Accessibility Survey

City of Downey Via Amorita - Bellder Drive to Bellman Avenue

Date of Inspection
7/28/2017

Prepared By
Disability Access Consultants
(800) 743-7067

Tree West Of Old River School Road @ 33.956812041628, -118.142868876457

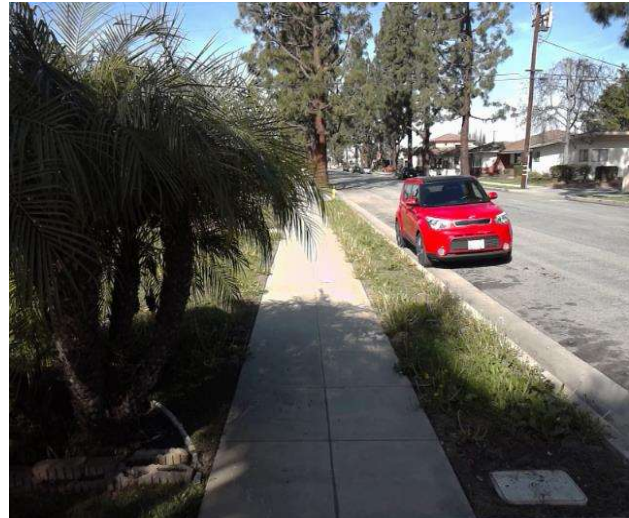
Finding

Overhead obstruction height is not compliant.

On-Site Finding 55.00 inches

Provide a compliant vertical clearance height.

Recommendation At least 80.00 inches
